Plan Commission

Special Meeting

Agenda

SUBJECT: Consideration and possible action on major design exceptions from Zoning Ordinance Sections 14-92(4)(d), 114-33(3)(b) [Table 3-3], and 14-33(4)(c), related to balconies and upper-level step-backs at 550 William ST (Parcel ED-875-1).

DESIGN EXCEPTION 2

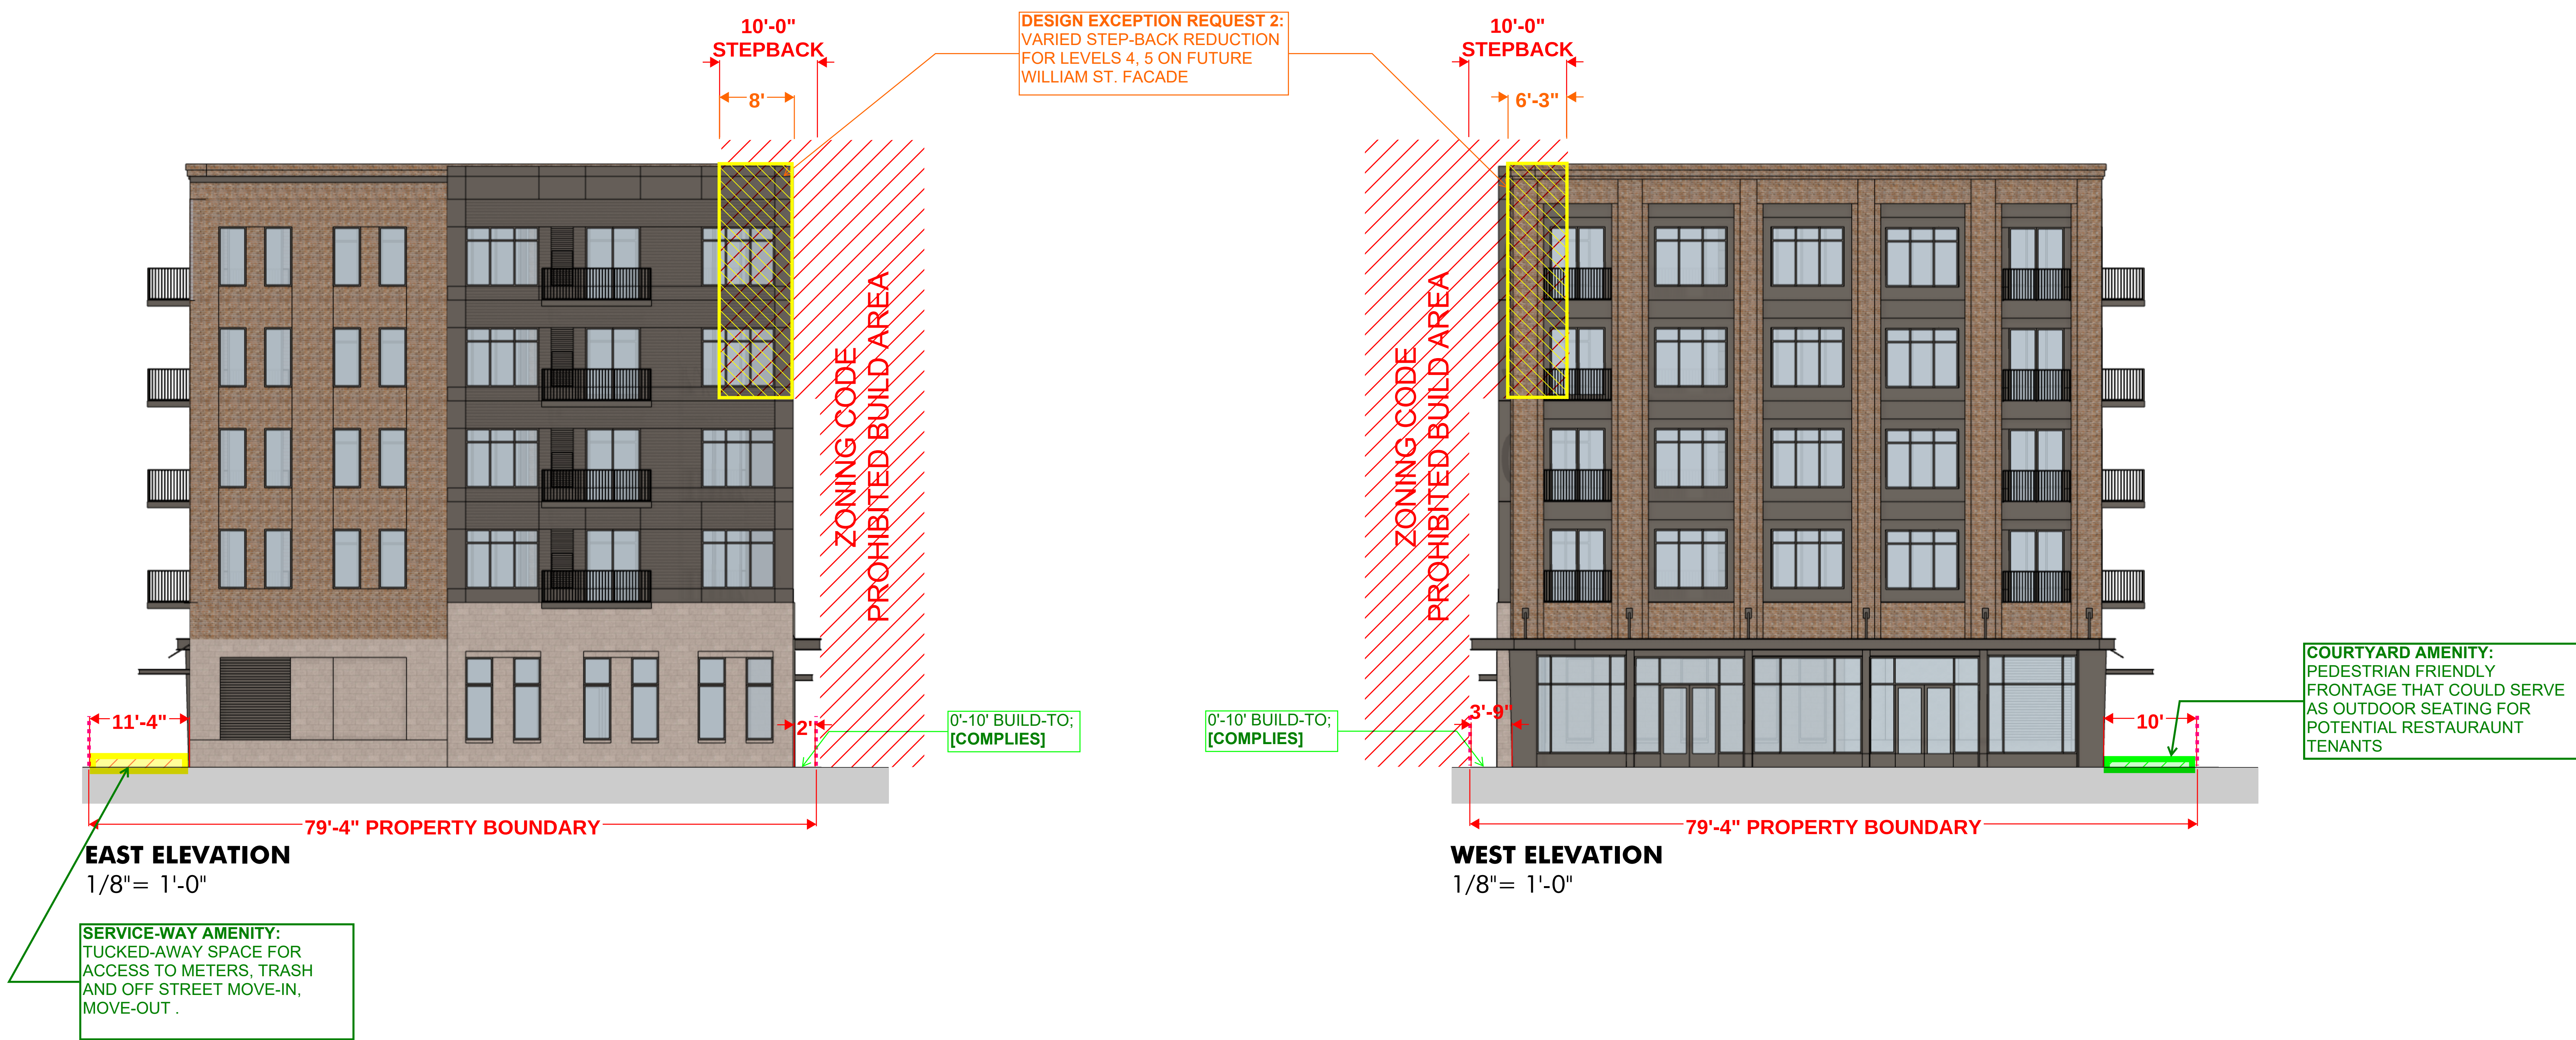
14-33 Table 3.3 dictates:
Non-primary frontage Build-to zone of 0-10 feet. (North Frontage)
Minimum Side Setback 5 feet when abutting another building type (South Frontage)
Step backs required above 3rd story in alignment with 14-33(4)
14-33(4)(c) dictates step-back of at least 10' from property line.

The project as proposed meets requirements for all build-to zoning in respect of the pedestrian nature of the MX-1 district with a strong urban presence with the northern exterior wall 3.7' from the property line on the western portion, and 2.6' on the eastern portion respectively. This push north enables the first floor to provide 10'-12' to the property line on the south that proves critical to the urban fabric and functionality of the building. On the west side, this additional space allows for a moment of relief between the parking ramp and first floor retail that the project intends to utilize to create a courtyard as an amenity to pedestrians and to serve as additional seating space for any potential restaurant tenants. Center-block, a canopy gestures connection to the parking ramp and affords residents parking in the ramp an opportunity to enter the multifamily building directly and in a weather-protected fashion. Beyond the connection to the east, the space between the ramp and mixed-use building is utilized to house the necessary utilitarian elements of the building (meters, outdoor mechanical equipment, trash service, and move-in, move-out service). This move preserves the pedestrian-friendly appeal of the three street frontages, while affording the opportunity for the building to have a modest "back-of-house" out of sight from the downtown district and neighboring residents.

The cost of this move is a reduction in the step-back that is required from the northern property line from what the the code dictates. The project team believes the benefits of the move outweigh the costs, and the intent of creating a pedestrian friendly scale while retaining historic massing is still achieved via the combination of street plantings, material transition between the first and second floor, and use of canopy overhangs.

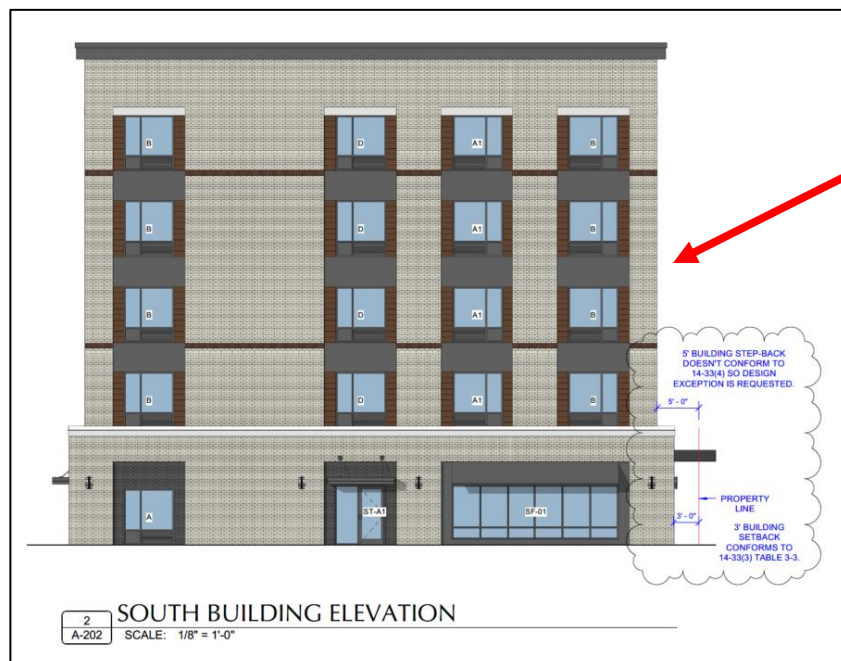
Major Design Exception Request: Step-back on the southern 95'4" of the east façade that is reduced from 10-feet to 5-feet above the third story.

The first floor of the proposed building is located three-feet from the property line, which is properly located within the 0-5-foot Build-to Zone. The fourth and fifth floors do not properly address the required step-backs

- The design of the east façade of the building is prohibited, per Zoning Ordinances 14-33(3)(b) [Table 3-3 Maximum Height] and 14-33(4)(c), because the N Wisconsin ST facing façade does not step back 10-feet from the property line on floors four and five. The proposed southern 95'4" foot long end of the upper floors is 5-feet from the property line.

1
A-202
WEST BUILDING ELEVATION
SCALE: 1/8" = 1'-0"

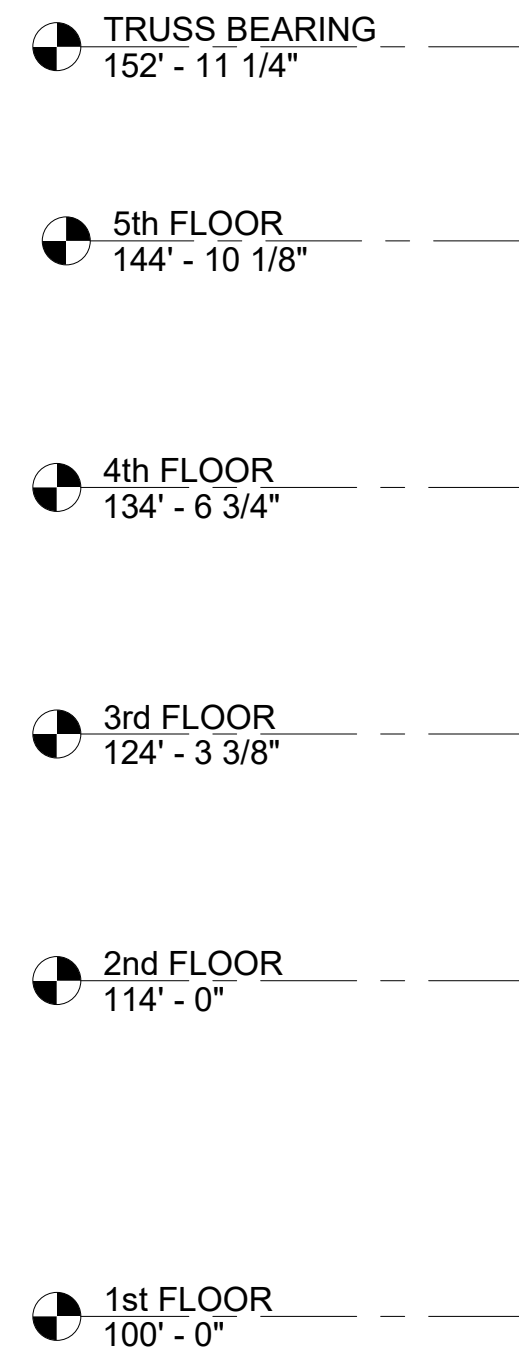
DESIGN EXCEPTION REQUESTED
